CONSOLIDATED COMMENTS
KINGSTON ARTS PRECINCT - DRAFT MAJOR SUBDIVISIONS (ESTATES)
CIRCULATION 1 – 31 January 2025

All agency comments have been consolidated into the table of response below for the Developer's consideration, response and or action.

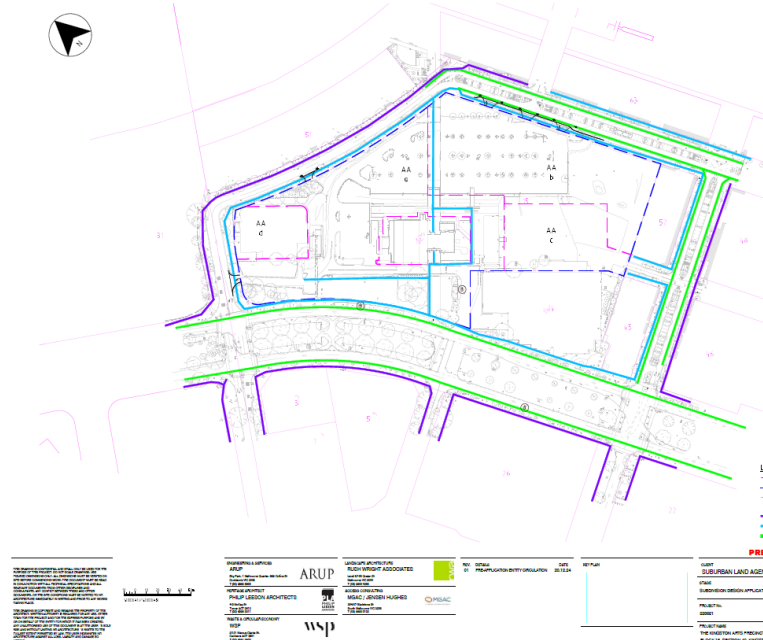
- A. Please confirm if new services are proposed along Eastlake Parade and show on the TMP, including Pipe Protection Envelope (PPE). There are many civil drawings that are already fairly advanced and TCCS want to ensure that trees (existing

27/5 Meeting: Amend verge works plan to overlay services for the purposes of Authority review of potential clash between services (existing and proposed) and trees (existing and proposed).

- A. For further discussion with TCCS. Engagement with TCCS is underway to further resolve TMP coordination. On block work will be undertaken as part of future DAs. Existing and proposed services can be shown indicatively on Verge Works Plan.

There are some minor adjustments to sewer on Eastlake. In the future there may be further adjustments to comms connections but the final location and detailing the of connections would be developed in subsequent stages once the connection points are finalised as part of future DA.

Part of this SDA requires ALL services to touch block boundary. If we are seeking proposed services approval in this SDA it will be shown. Otherwise it is not seeking approval and part of future works."

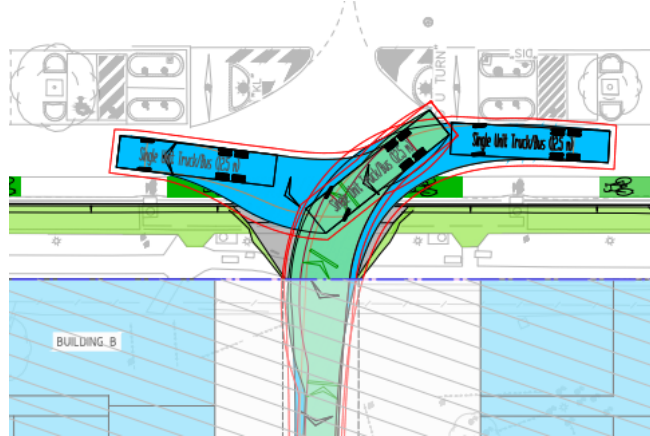
- A. Waste proposal will need to comply with the DCC Waste Code 2019. At present, some of the proposed truck movements appear to have conflicts with kerbs, parking areas or may require more than a 3-point turn, which will not supported. Please ensure the design meets the expectations of the waste code and provides for safe movement for HRV within the

- B. The proposed HRV truck movement/loop around the multi-story car park at Printers Way entry is not ideal and needs to be further resolved.

- A. Waste vehicles at the logistic road are under further detailed investigation but have been based on a 12.5m vehicle. The road design will be refined further in subsequent design stages.
- B. The road design will be refined further in subsequent design stages
